# CITY OF TAMPA

## ADDENDUM NO. 1

**DATE: September 23, 2015**

Contract 15-C-00040; West River Trail Phase 2 U.T. – Sheltered Market

C1.2

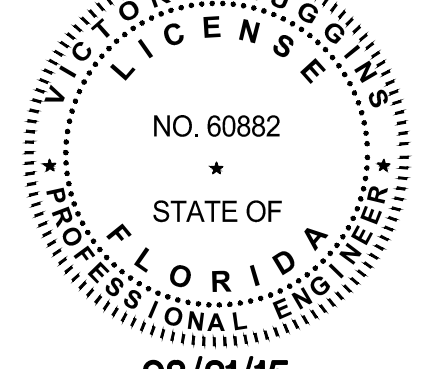
Item 2: Replace Drawing C-1.2 with the attached Drawing C-12, revised 09/21/15. Access Clarification: The concrete trucks will have to stay on the pavement portion of the access route and pump concrete from this area.

C3.0

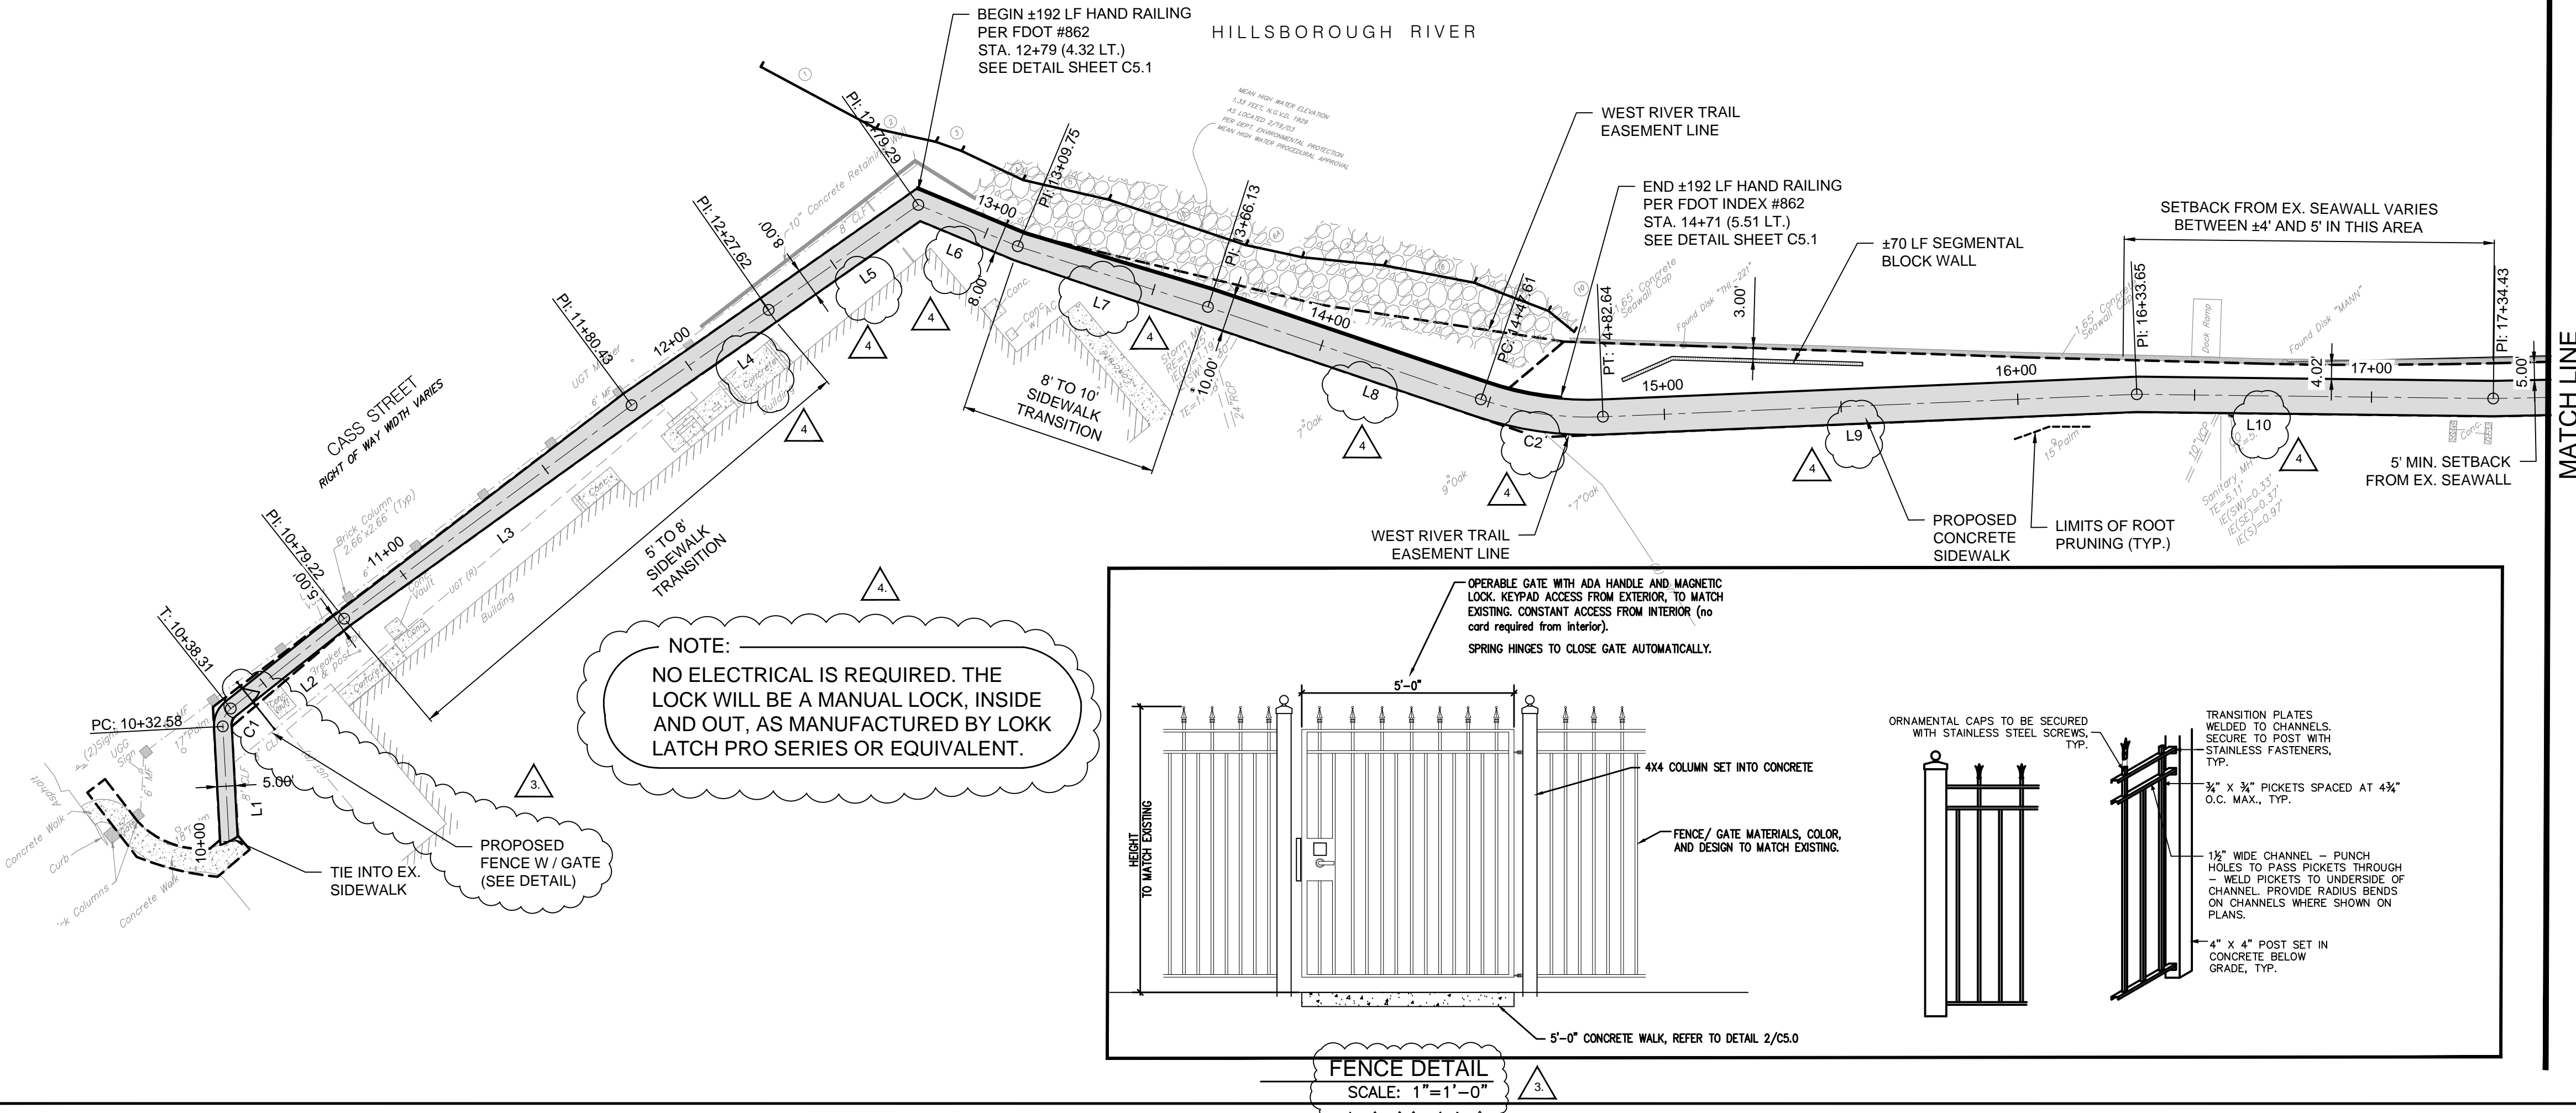
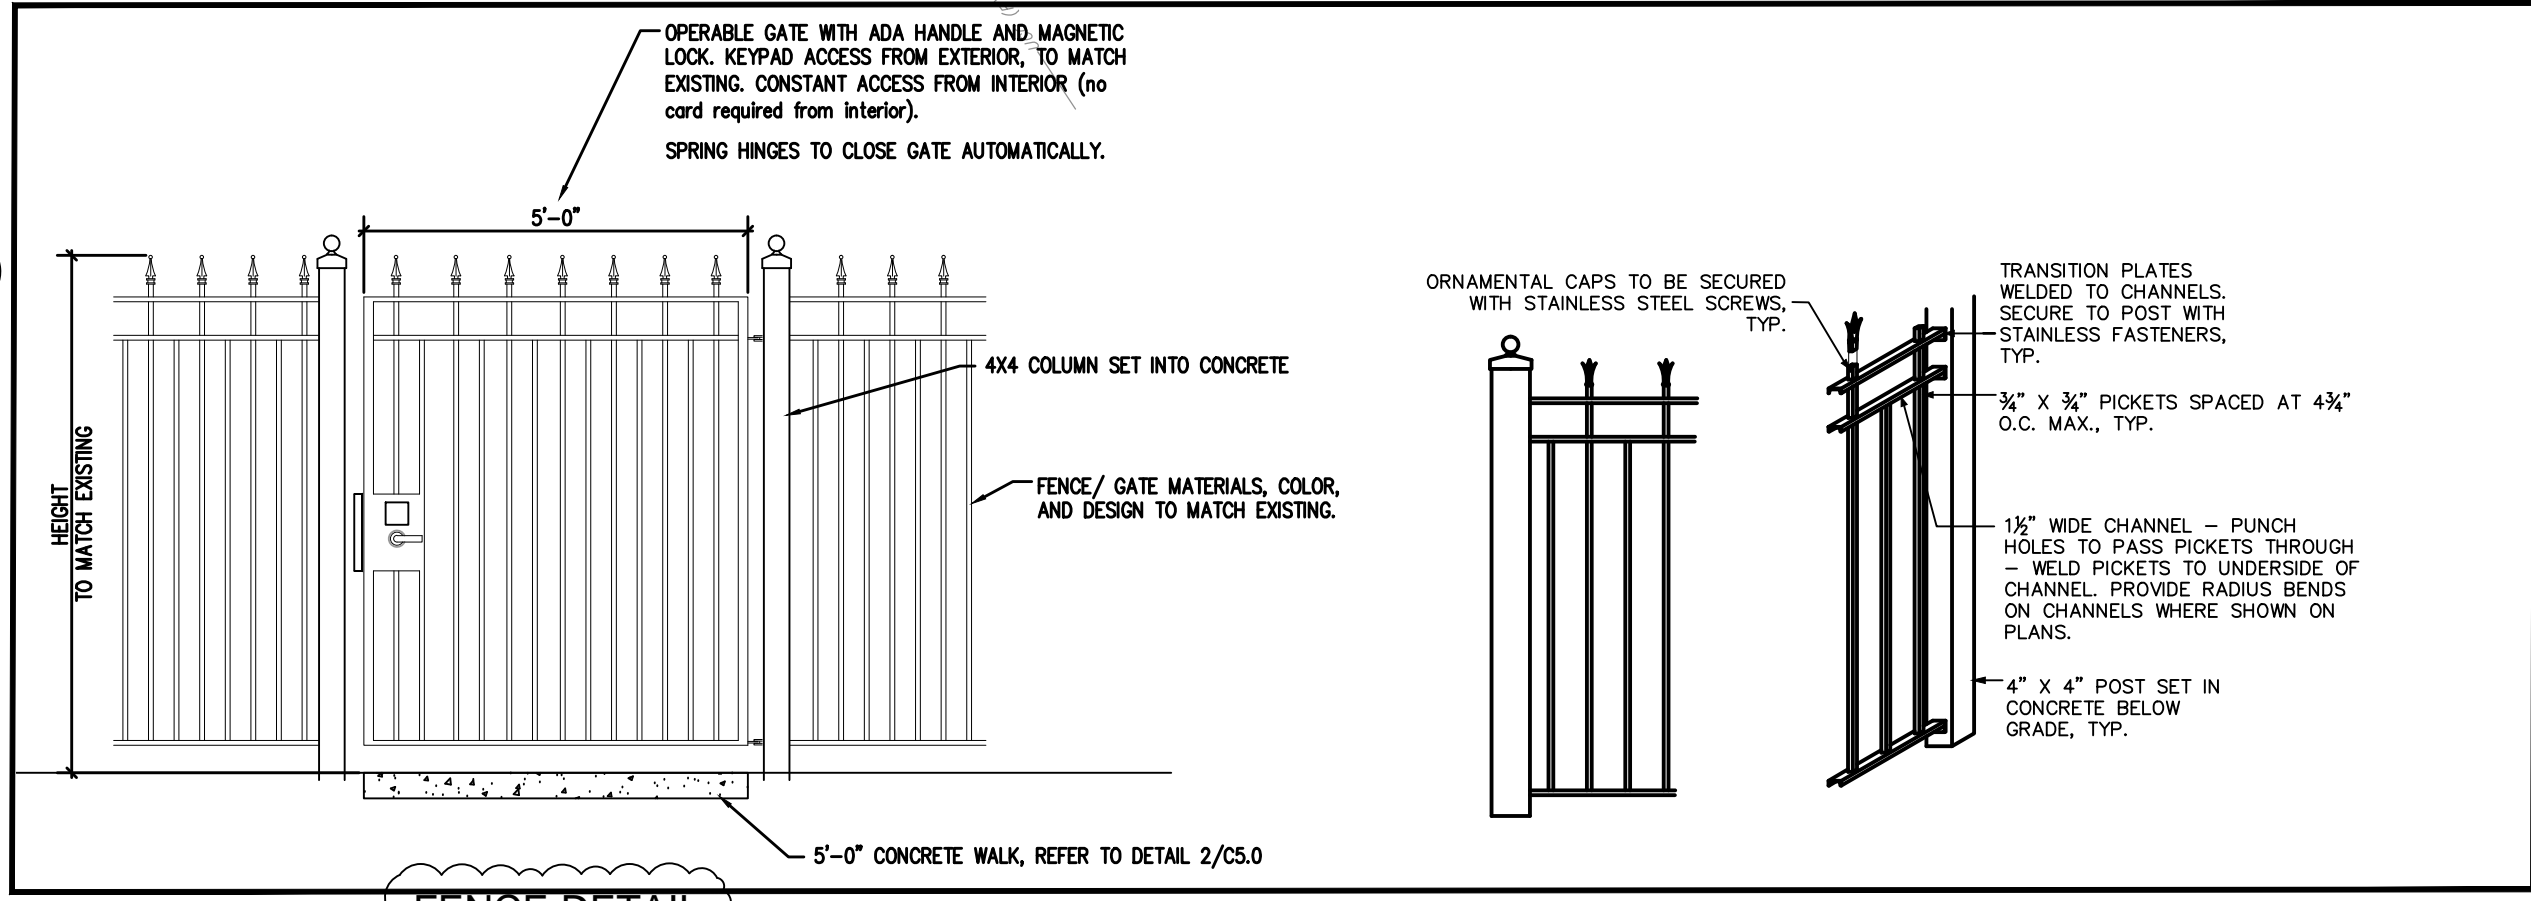
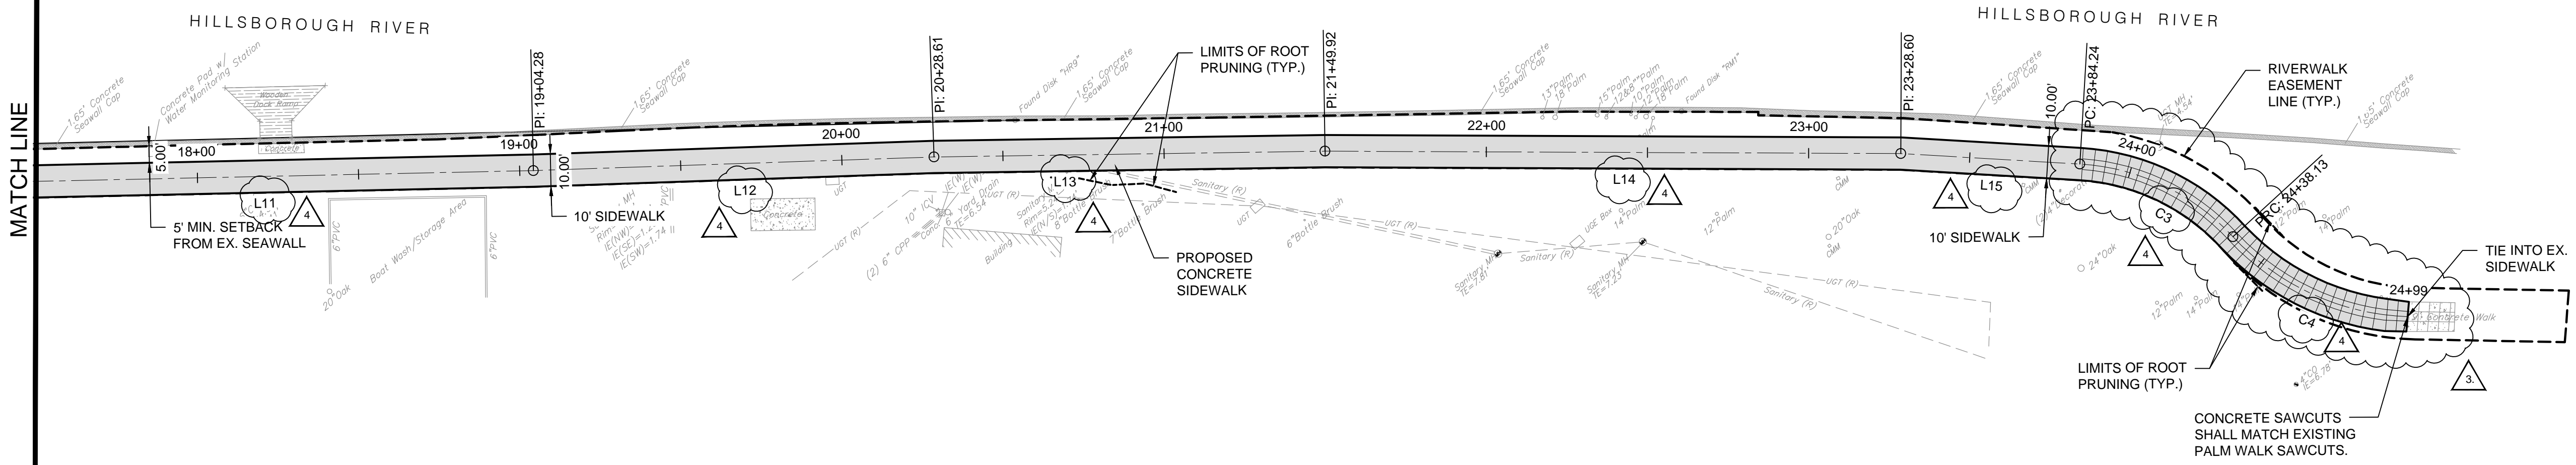
Item 3: Replace Drawing C-3.0, with attached Drawing C-3.0, revised 09/21/15. This Drawing Sheet revises the line table information and curve numbers revision. The line and curve numbers were revised and sequentially numbered to match the table.

1 SIDEWALK JOINT DETAIL

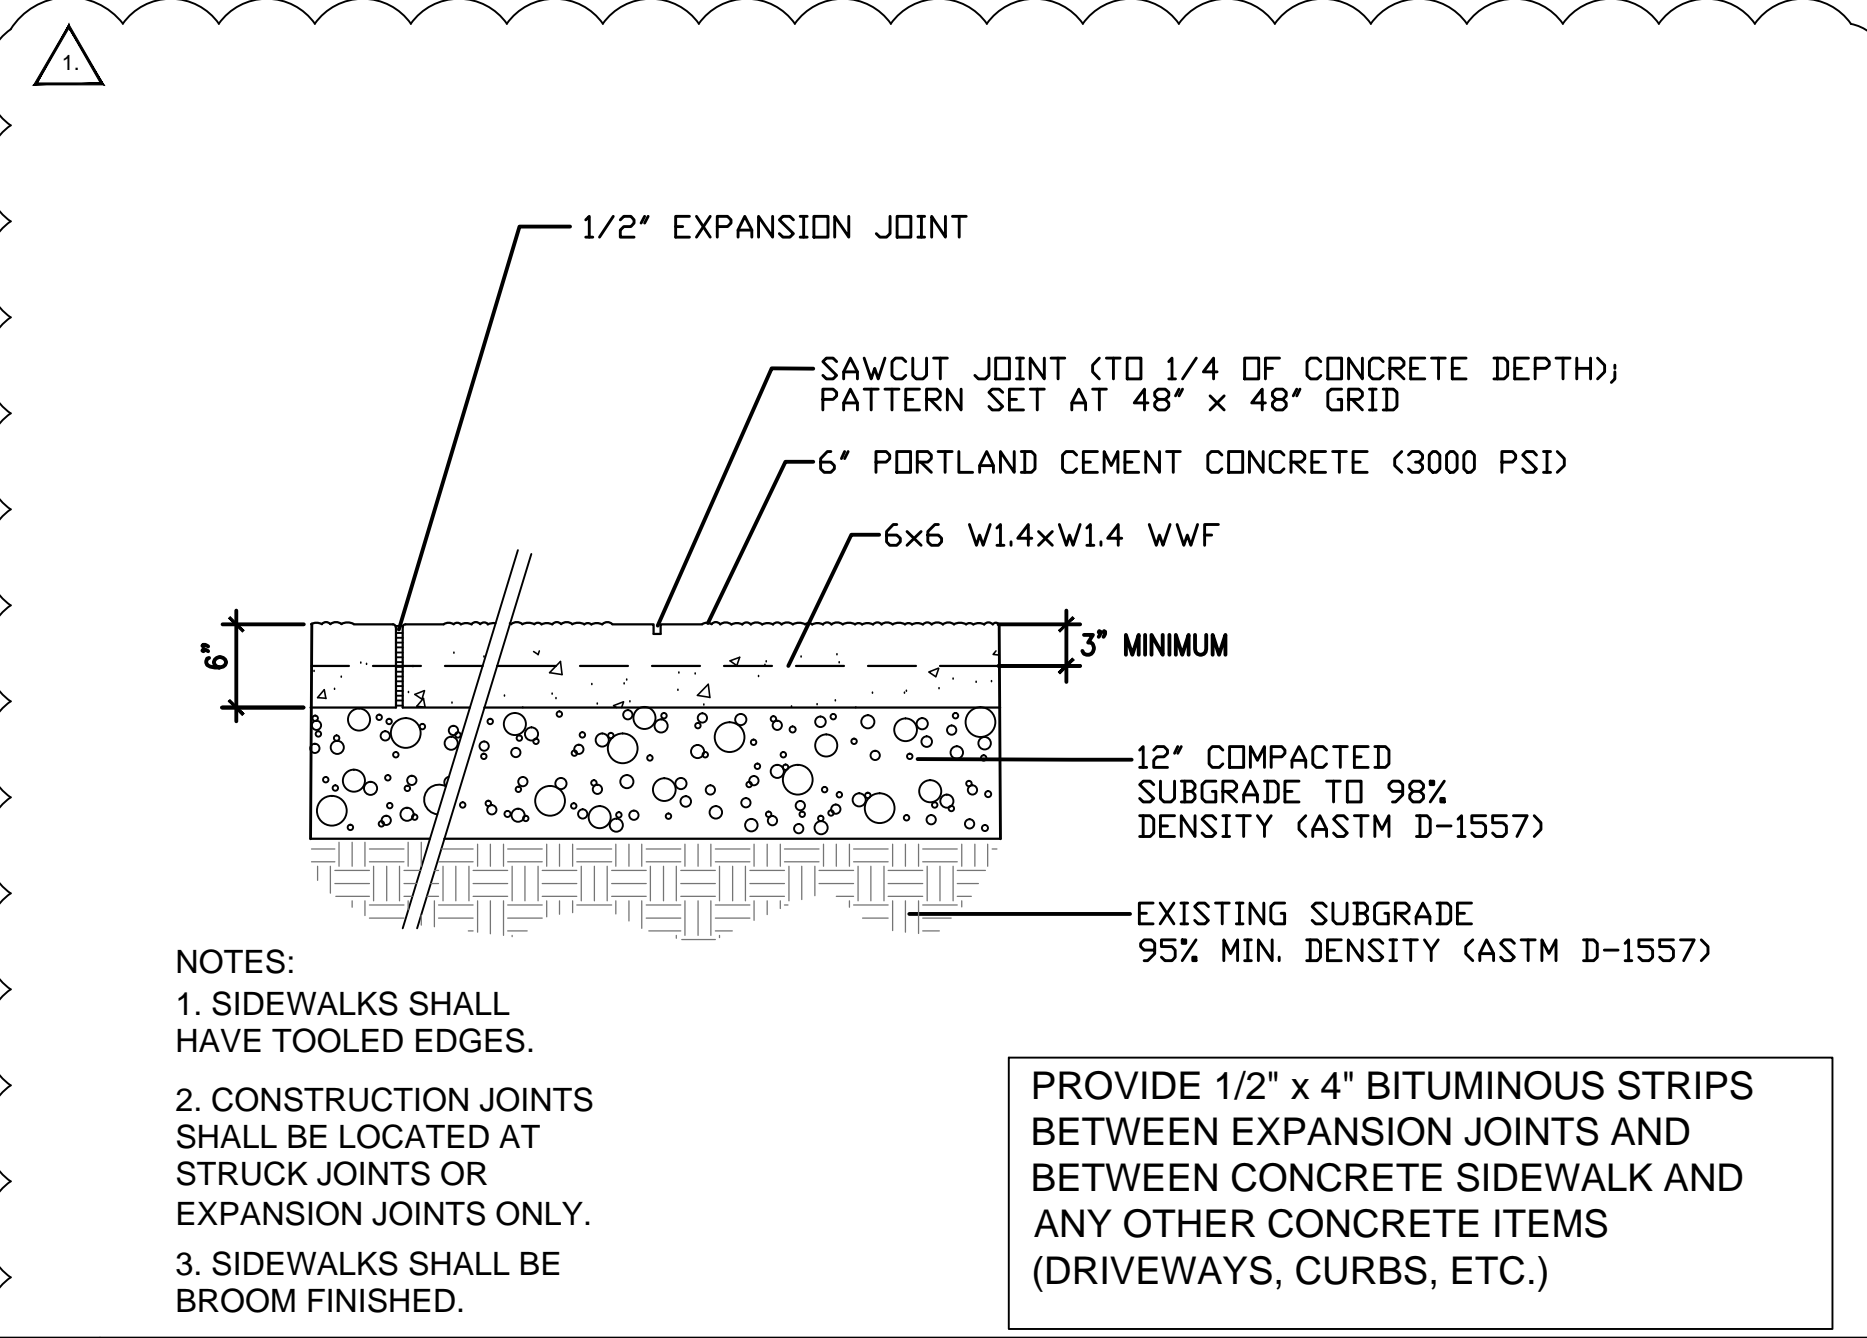
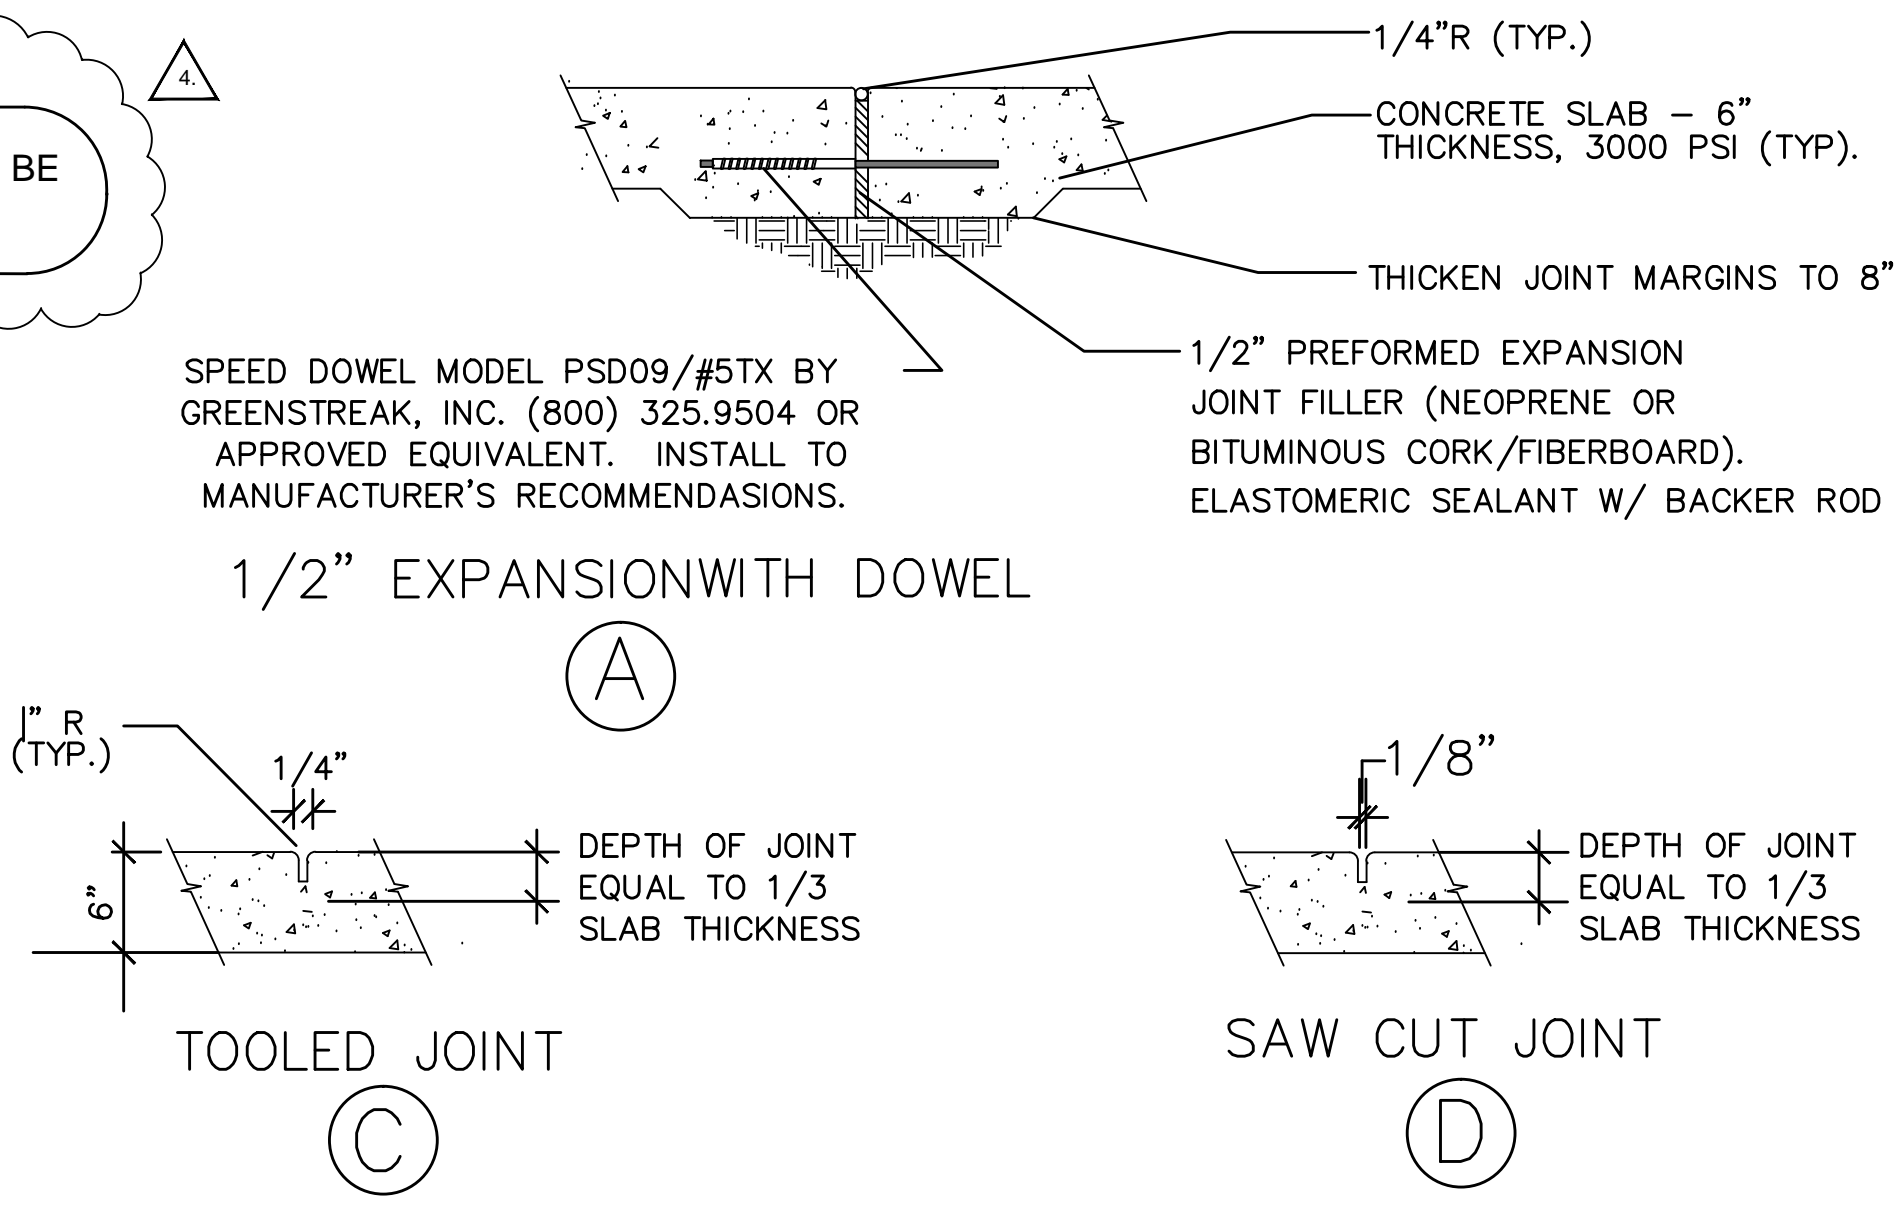
Item 4: Replace Drawing C5.0 with the attached Drawing C-5.0, revised 09/21/15. Dowel Spacing Clarification: Spacing of the dowels should be 18" O.C.

NOTE:  
SPACING OF THE DOWELS SHOULD BE 18" O.C.
